Safety Evaluation Report

University of Wisconsin

Docket No. 50-156

Safety Evaluation Report Related to the Renewal of  
the Facility License for the TRIGA Reactor at the  
University of Wisconsin

**Figure 2.1 Historical Pool Water Makeup Trend**

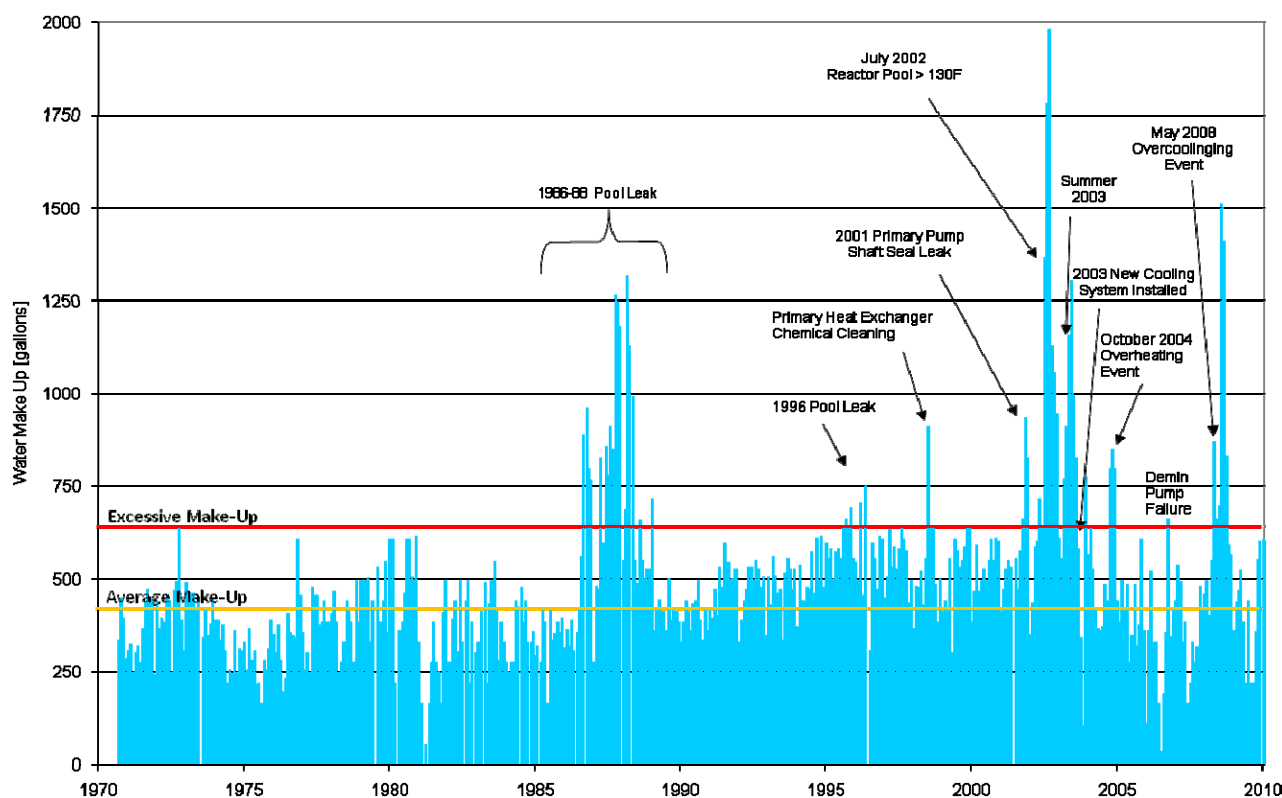
In the event that the pool leak reinitiates and an increased trend in leakage is identified, the licensee has established limits for further operation of the facility. Through the licensee response to RAI No. 1 in a letter dated June 16, 2010 (Ref 20), the licensee stated that it will adhere to the mandates of the UWNR RSC, which, in 2003, mandated a reactor shutdown and an immediate repair if either of the following conditions occurs:

- (1) pool water makeup greater than 2,200 gallons per month, or
- (2) pool water activity approaching 80 percent of 10 CFR Part 20, Appendix B, Table 2, water effluent concentration limits for isotopes with half-lives greater than 24 hours.

As the RSC limitations would prevent the licensee from exceeding 10 CFR Part 20, Appendix B, Table 2, limits, the NRC staff finds the above commitment acceptable.

**Figure -1 Organizational Chart**

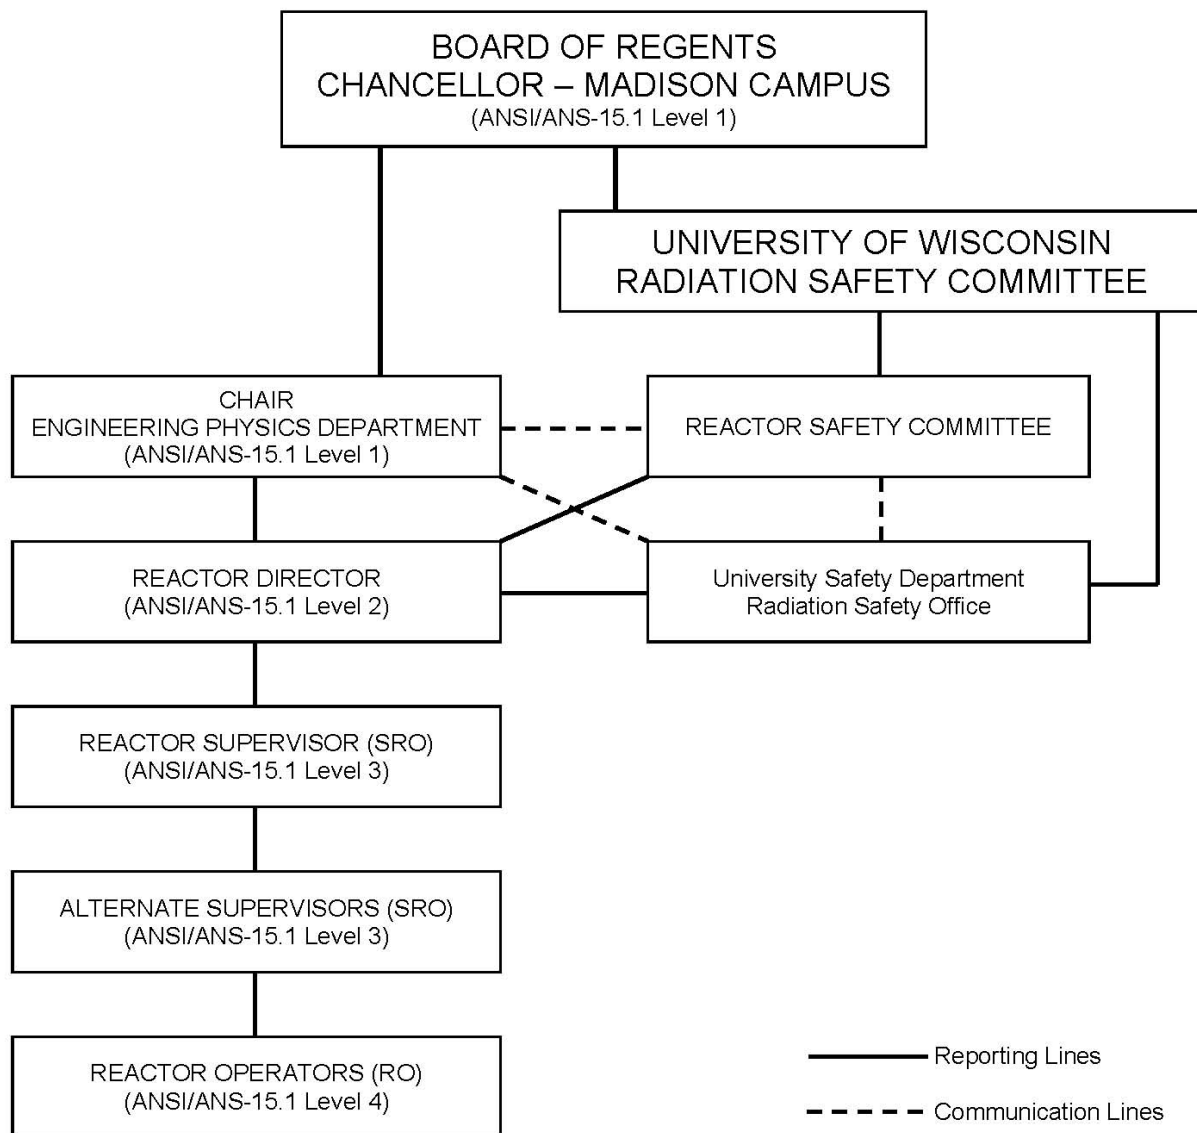
Responsibility for the safe operation of the reactor facility is vested within the chain of command shown in TS Figure -1, which depicts the licensee's organization. The organizational

responsibilities delineated in TS Figure -1 are consistent with the guidance in provided in NUREG-1537 and ANSI/ANS-15.1-2007 and are, therefore, acceptable to the NRC staff.

Certain Level 1 responsibilities of the Board of Regents of UW, the holder of the reactor license, are delegated to the Engineering Physics Department chair. The licensee revised the organizational chart (Figure -1) to reflect this clarification.
